Product Change Notification

PCN19-09 - KSS, KMS, KSU marking

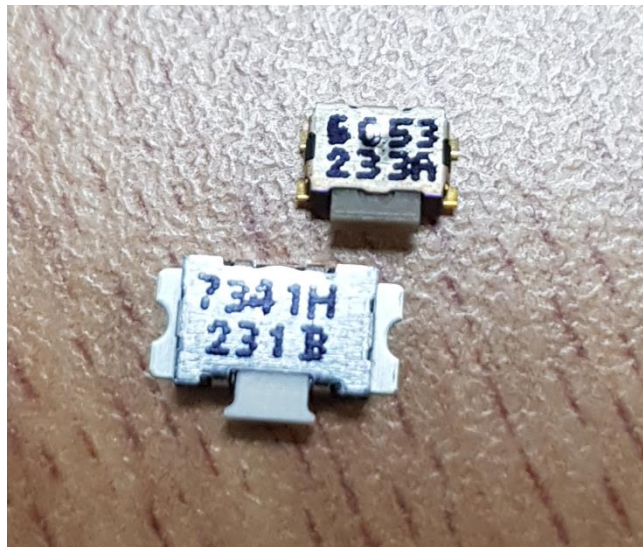
As part of this continuous improvement policy, in order to avoid contamination, we are stopping the ink jet marking on top of the metal cage for KSS, KMS and KSU series.

Today, all KSS, KMS and KSU have an inkjet marking related to the date code and the version number:

This marking induce a possible risk of pollution and contamination on the assembly lines. The date code is also located on the label affixed to the plastic flange of the reel so traceability is ensured like all the other C&K products.
